FINAL-As-Built Baseline Monitoring Report
Seniard Creek Mitigation Site

NCDMS Project No. 100017

Re: Draft As-Built Baseline Monitoring Report (Task 6)
Seniard Creek Mitigation Project,
Henderson County French Broad River CU 06010105
DMS Project ID No. 100017 / DEQ Contract #7189

CCPV MY0
 Sheet Key
 Seniard Creek
 Stream Restoration Site
 Henderson Co., NC
 April 2021

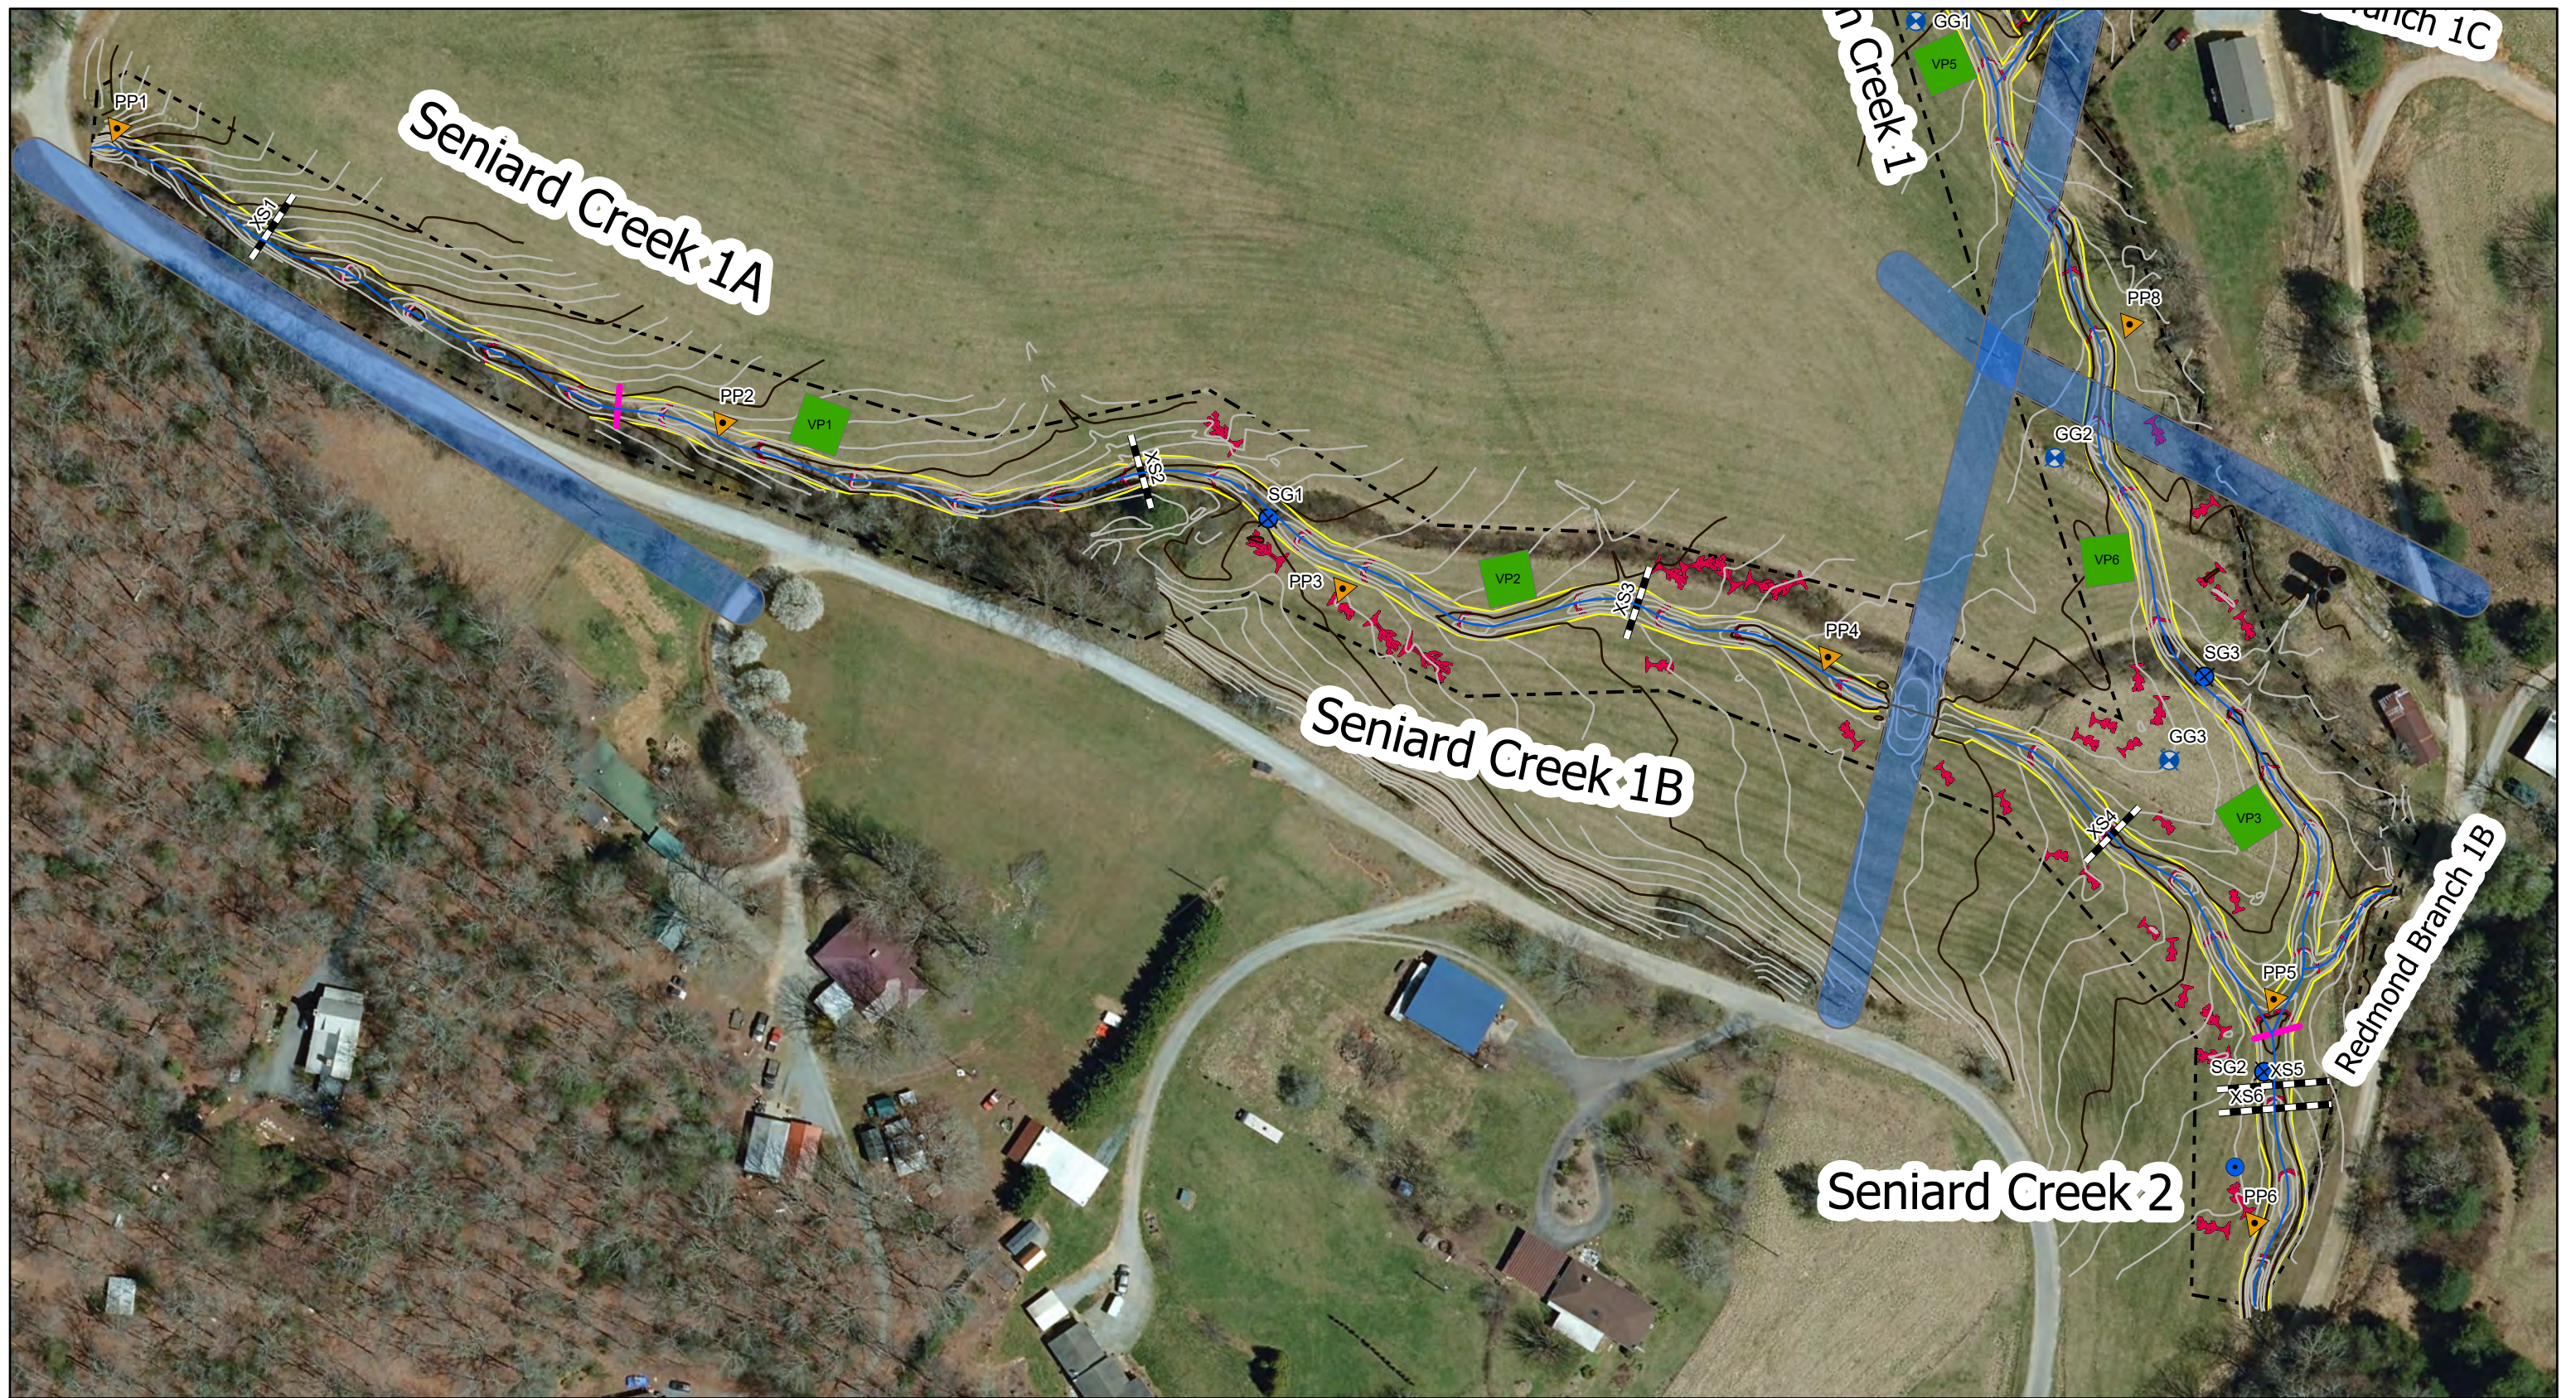
Monitoring features map sheet key – could we possibly just label the stream reaches alongside the reaches, rather than have pointer lines everywhere? That would be preferable. If you have to keep the pointer lines please change the color from black to white or yellow as they are hard to read against all the other black lines. *Pointer lines removed and labels adjusted.*

Please include reach names on all of the monitoring features maps. These should also be re-named Current Conditions Plan View (CCPV) maps, and include the current monitoring year in the title block. *Map title changed and stream reach labels included on each sheet.*
